# Fix Data Bus control on 0.1.0 gb_rp2040_cart

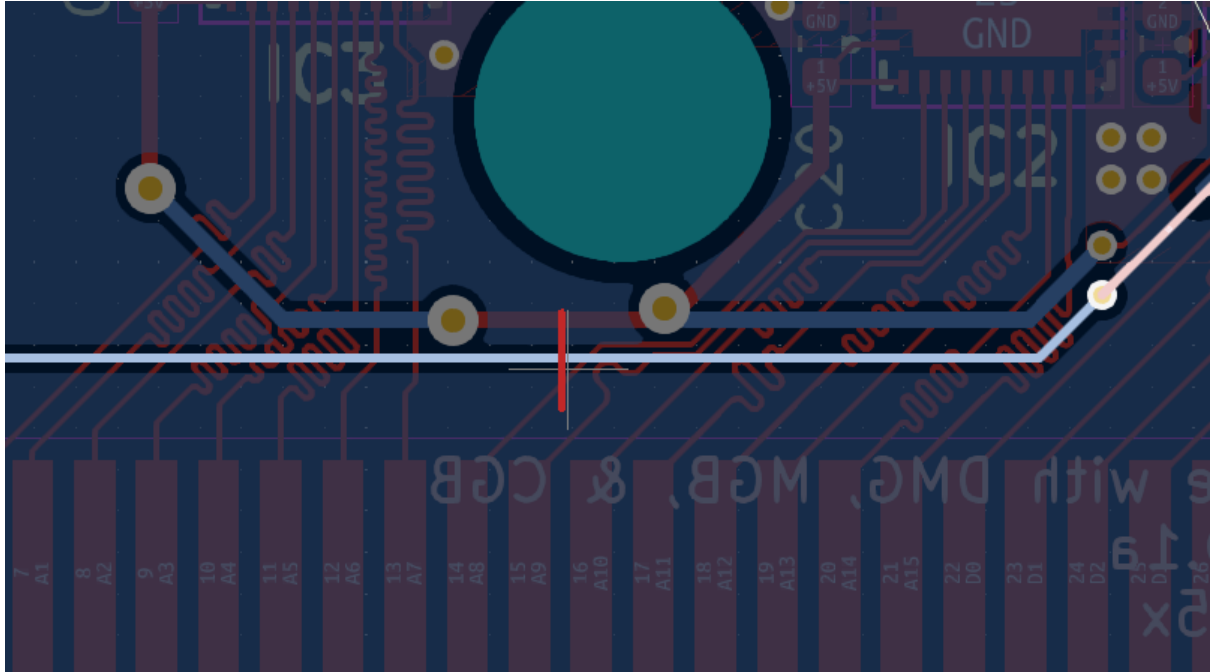
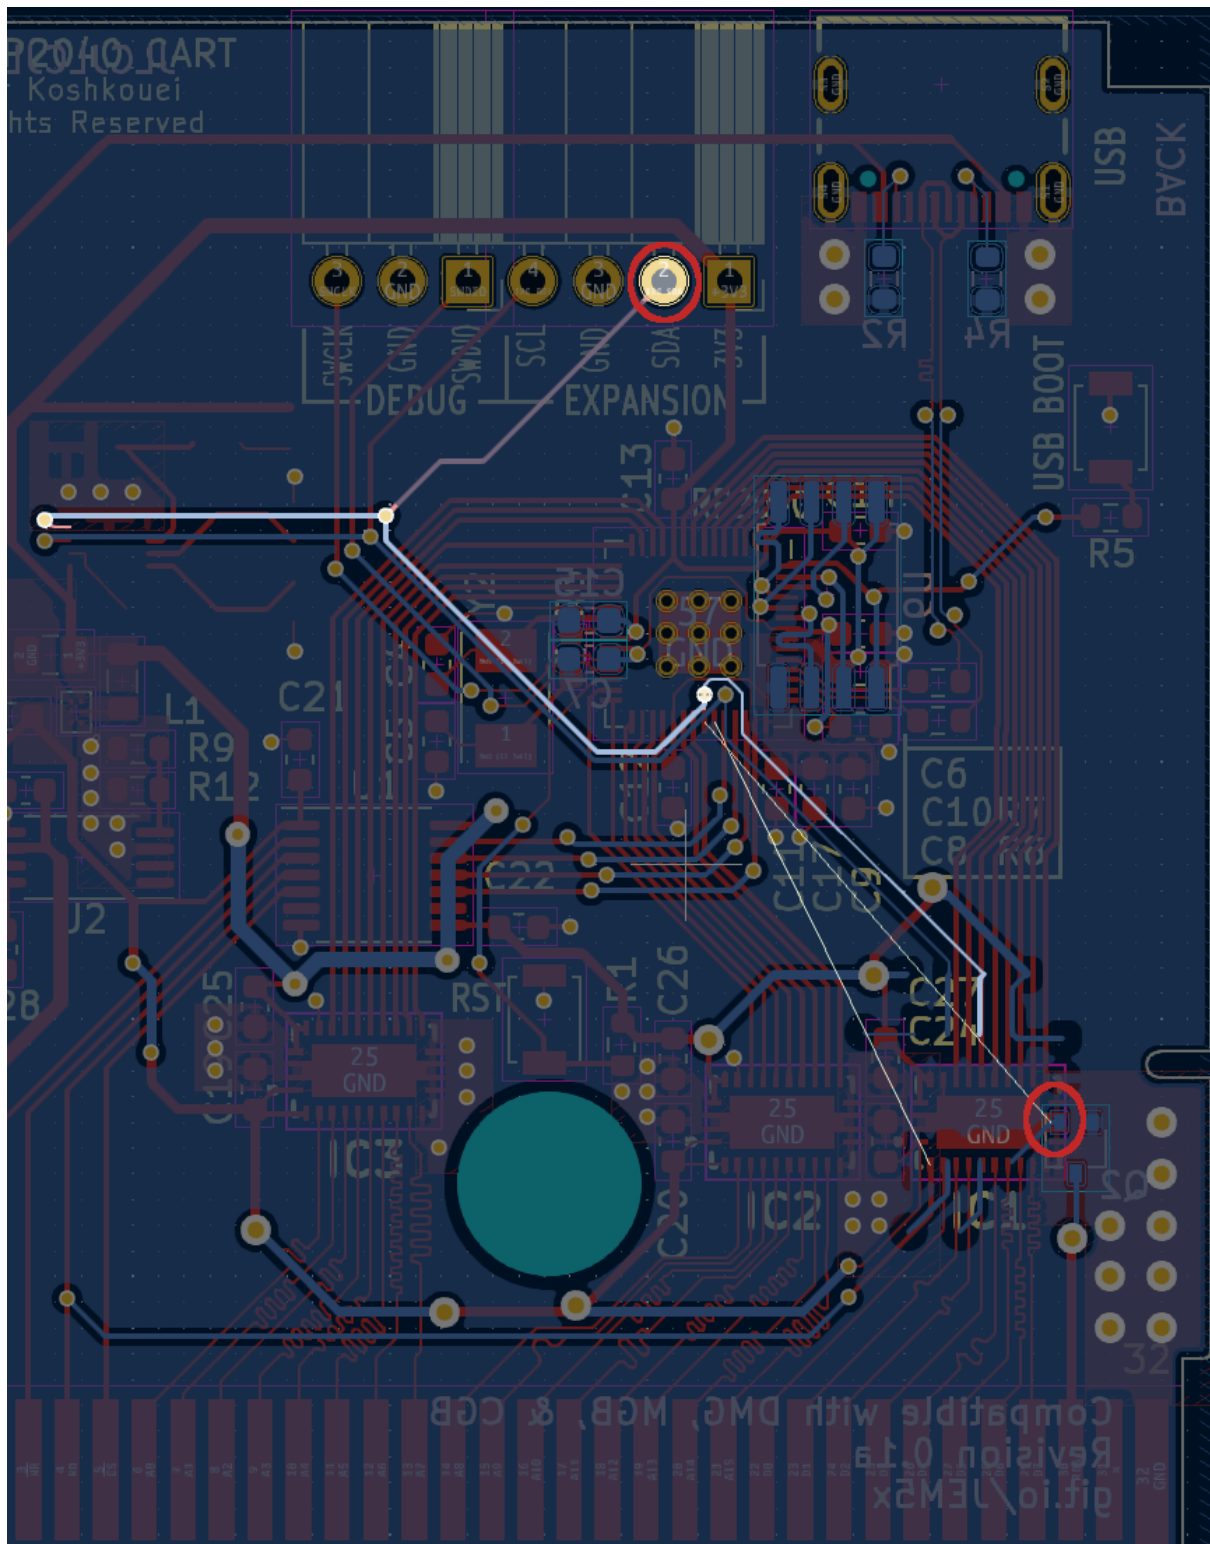
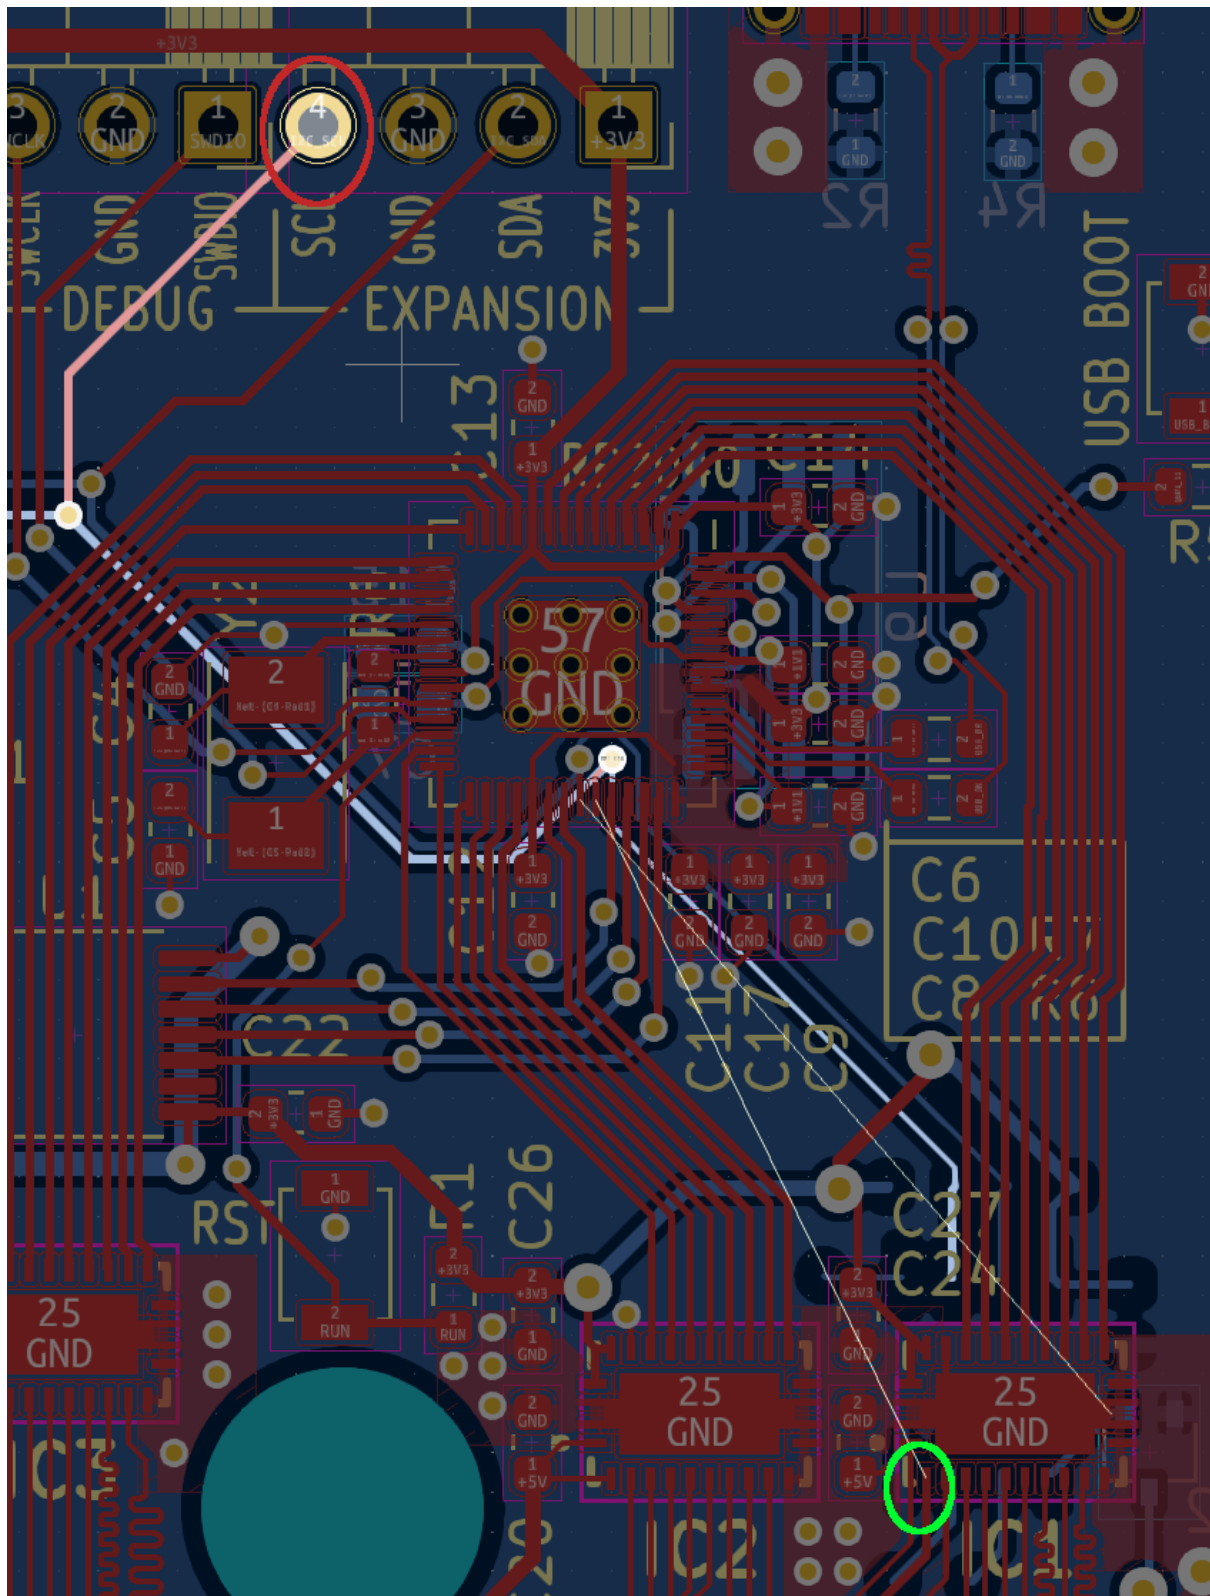
Cut this /RD track on the back of the PCB. Then choose one of the following sections.

For Dynamic Data Bus Direction Control

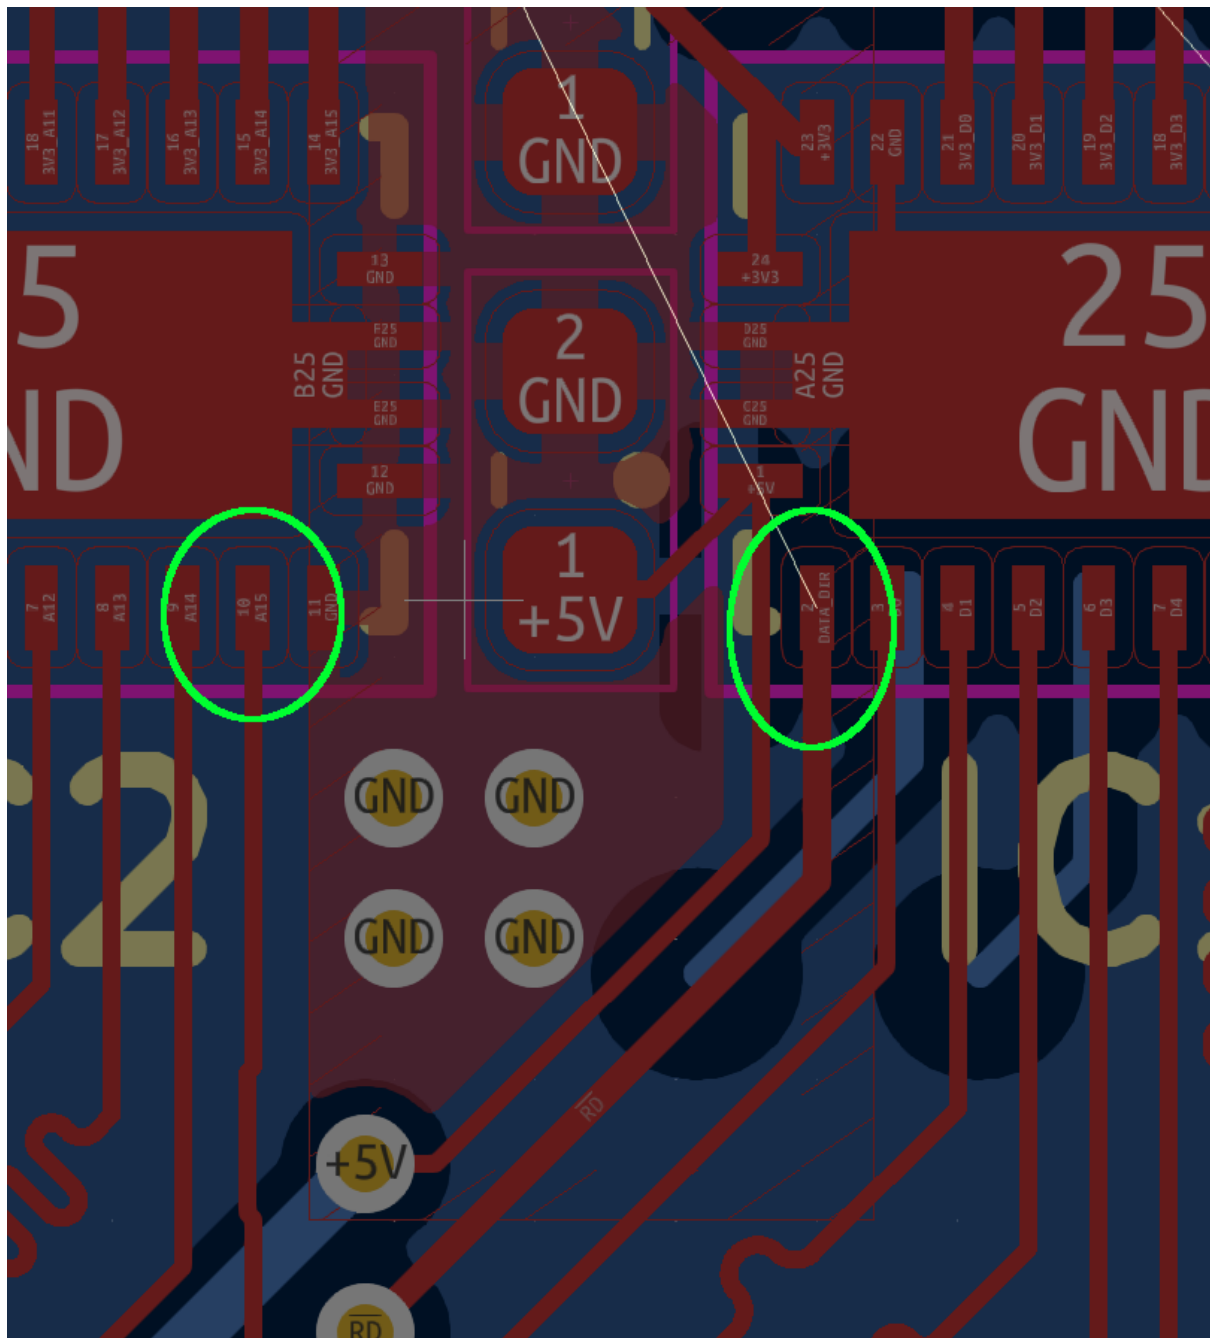
Connect these two pins with wire. This connects the now unused I2C_SDA line to RESET_GB.

Connect these two pins with wire. This connects the now unused I2C_SCL line to DATA_DIR.
